U. S. NUCLEAR REGULATORY COMMISSION

Report No. 50-311/86-26  
Docket No. 50-311  
License No. DPR-75  
Licensee: Public Service Electric and Gas Company  
80 Park Plaza  
Newark, New Jersey 07101  
Facility Name: Salem Nuclear Generating Station - Unit 2  
Inspection At: Hancocks Bridge, New Jersey  
Inspection Conducted: August 26, 1986 - August 30, 1986

Inspections on August 26, 1986 - August 30, 1986 (Report Number 50-311/86-26)

Areas Inspected: This special inspection was conducted to evaluate a reactor trip with safety injection compounded by a false loss of offsite power (blackout) signal. The inspection team members reviewed licensee actions during and subsequent to the event.

# FIGURE 1 REACTOR COOLANT SYSTEM PARAMETERS

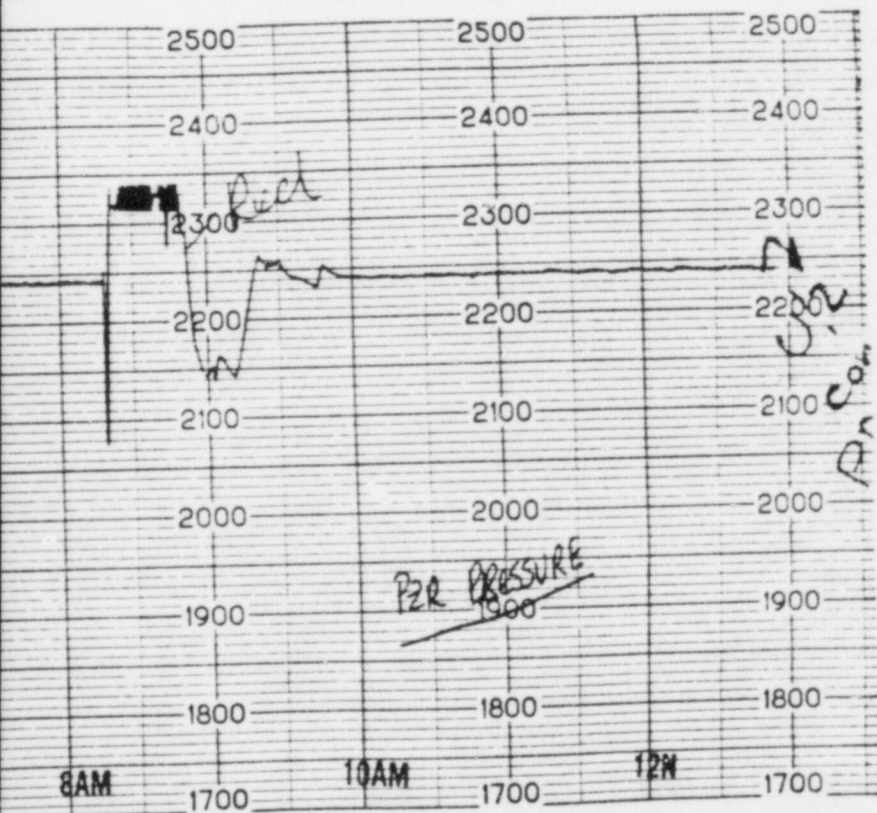
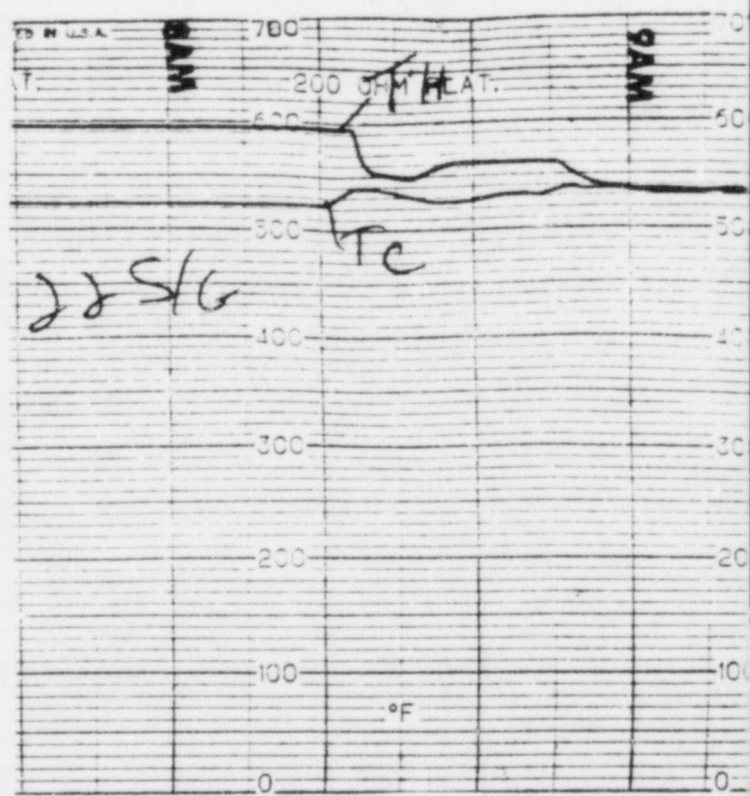
Figure 1 is the Control Room recorder traces for a) Pressurizer Pressure, b) Pressurizer Level and c) typical Reactor Coolant System loop temperatures. The pressure trace shows the initial safety injection, a lift of the pressurizer Power Operated Relief Valve (PORV), a period of stable pressure, then pressure control by means of numerous actuations and resets of the PORV. Termination of SI about 21 minutes after event initiation appears as a downward pressure spike with recovery to the PORV control band. The turning off of the RCPs and the establishment of natural circulation can be clearly seen from the RCS loop temperatures; the hot and cold leg temperatures converge as forced circulation ceases, then diverge to about 30 F difference for natural circulation, then converge again when 21 RCP is returned to service about 25 minutes into the event. The pressurizer pressure also quickly returns to normal as pressurizer spray becomes available and normal pressure control can be resumed. By 9:45 a.m. a second RCP was returned to operation and two of the vital buses had been returned to offsite power. By 12:30 p.m., the unit was stable in hot standby (Mode 3).

# FIGURE 2

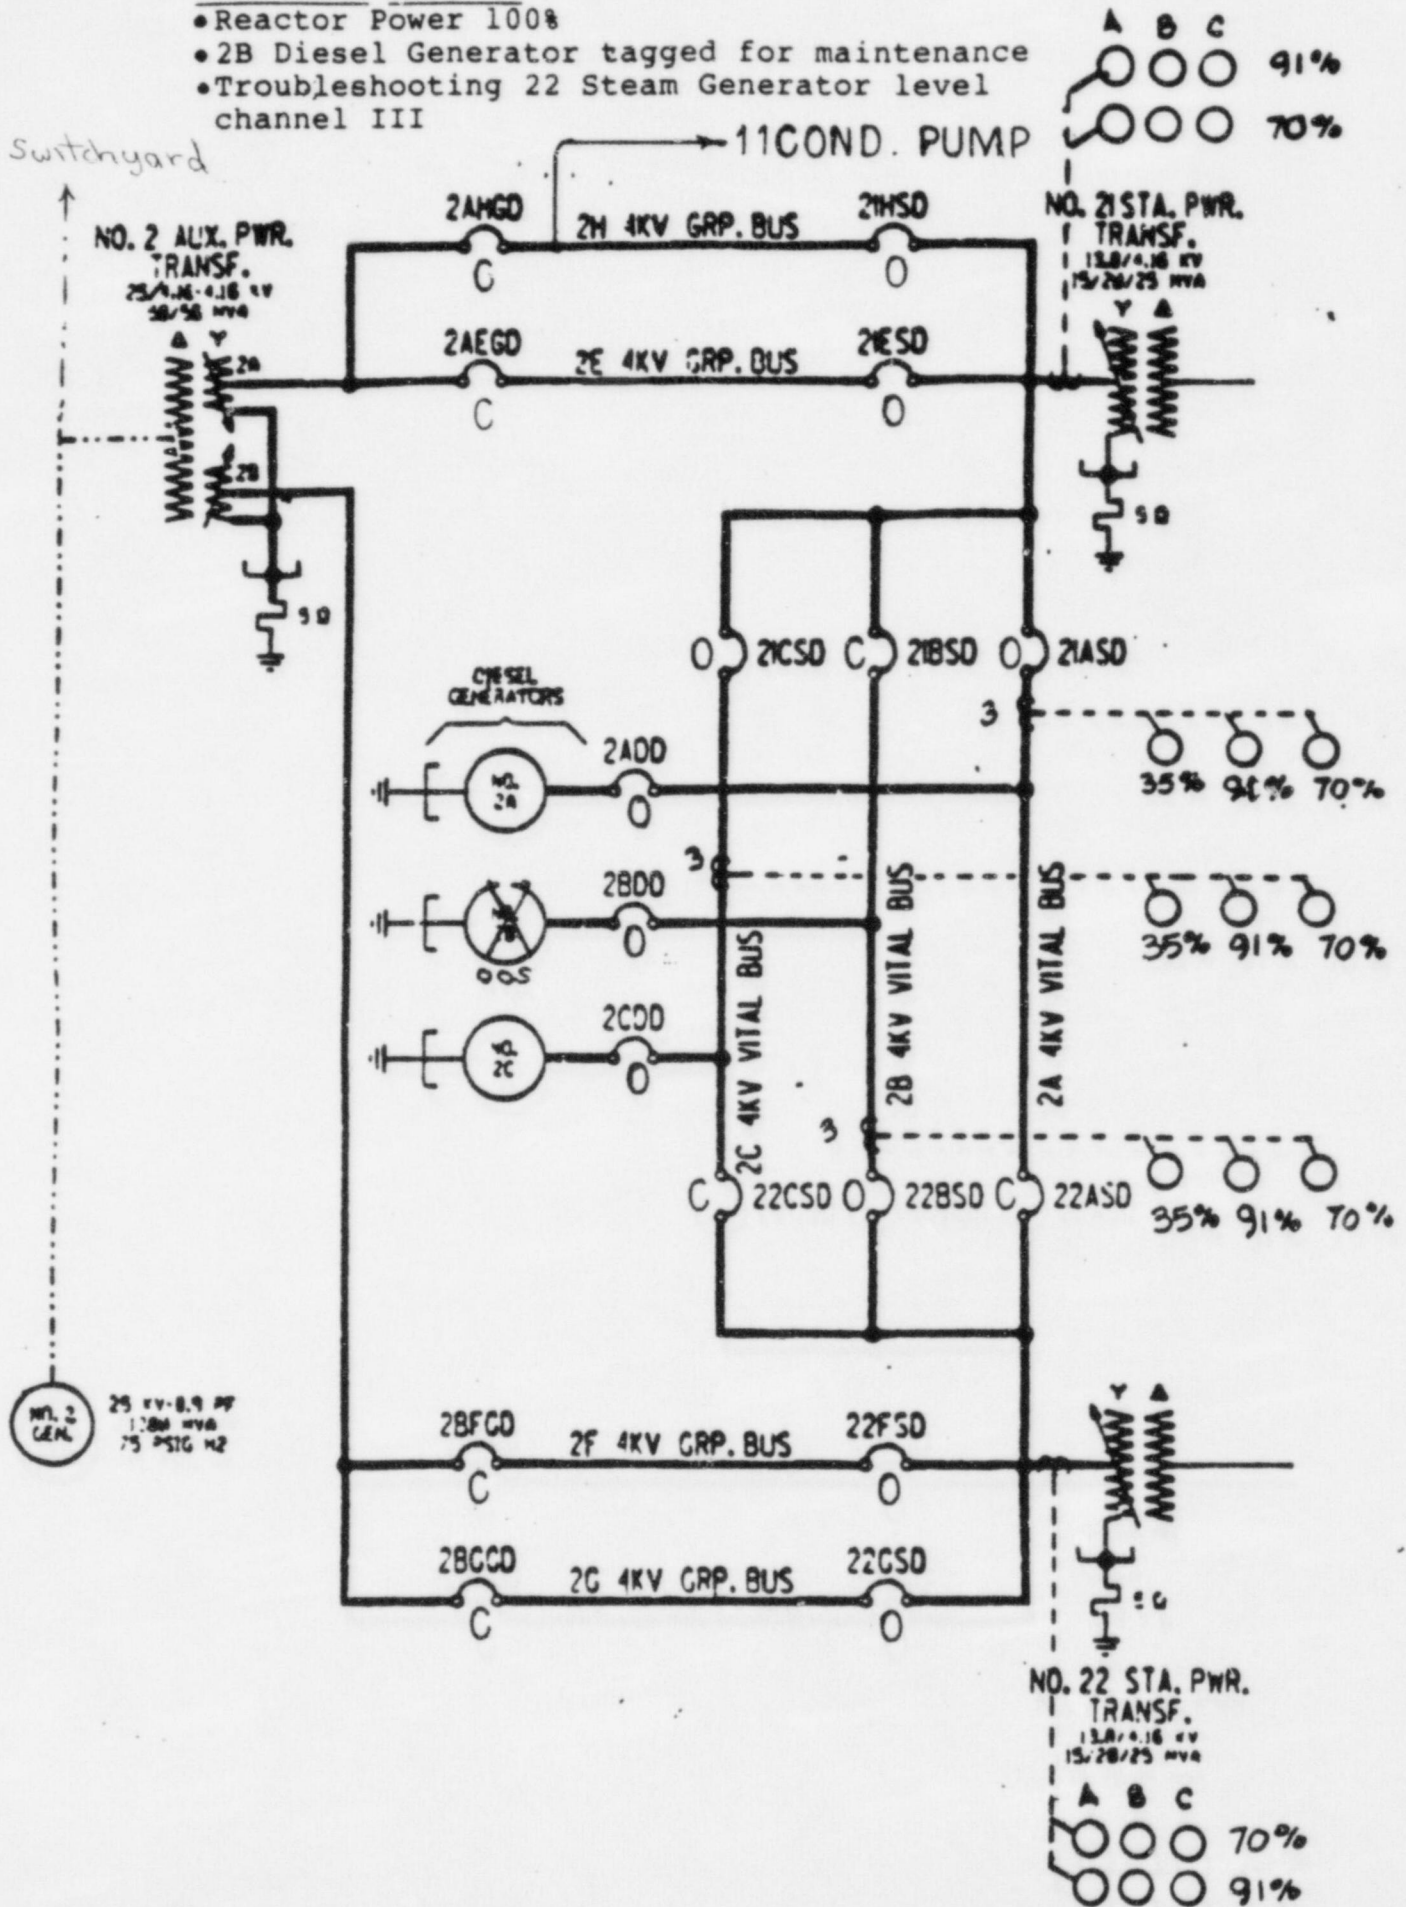
To understand why a false loss of offsite power signal was generated and why there were several transfers of vital buses, a great deal of analysis of available information was performed. This is described in some detail in Section 2.B. To explain a scenario, the pre-event electrical lineup depicted in Figure 2 is needed. In Fig. 2., it can be seen that the pre-event lineup had 2H, 2E, 2F and 2G Group Buses carrying normal station loads such as RCP's, Condensate Pumps, Circulating Water Pumps and Heater Drain Pumps connected to the Unit 2 generator thru No. 2 Auxiliary Power Transformer. In addition to its Unit 2 loads, the 2H Group Bus was supplying Unit 1 No. 11 Condensate Pump since a temporary hookup was completed on July 10, 1986. The Vital Bus alignment shows 2B connected to No. 21 Station Power Transformer (SPT 21) and buses 2A and 2C connected to SPT 22. The 2B D/G was out of service for maintenance and surveillance.

The Vital Buses (VB) have protective relaying, denoted by the groups of circles on Figure 2, to maintain the quality (voltage, power availability) of their source of supply. The undervoltage protection levels shown on Fig. 2 are 91% for degraded grid protection, 70% for equipment protection and 35% for reclosure permissive logic. The combination of load on SPT 22, the relay setting and an appropriate (10.5 sec.) time delay resulted in a signal from only the A 91% protective relay on SPT 22 for VBA to affect a transfer from SPT 22 to SPT 21; this is shown in the upper left portion of Fig. 3. VBC should also have transferred, but did not. No relay trip flag was observed for VBC. The licensee's explanation for this is slight differences in relay settings. The transfer of VBA now increased the electrical load on SPT 21.

Figure 2 shows a simplified electrical one line diagram of Salem Unit 2. During startup and shutdown, 4KV group buses 2E, 2F, 2G, and 2H and the vital buses 2A, 2B, and 2C are supplied from Station Power Transformers (SPTs) 21 and 22. After unit startup, the group buses are manually transferred to No. 2 Auxiliary Power Transformer (APT), which is the normal power supply for the group buses. On a unit trip, the group buses will automatically transfer to the SPTs (offsite source). When the unit is running, the vital buses continue to be supplied by SPTs 21 and 22. Normally two vital buses
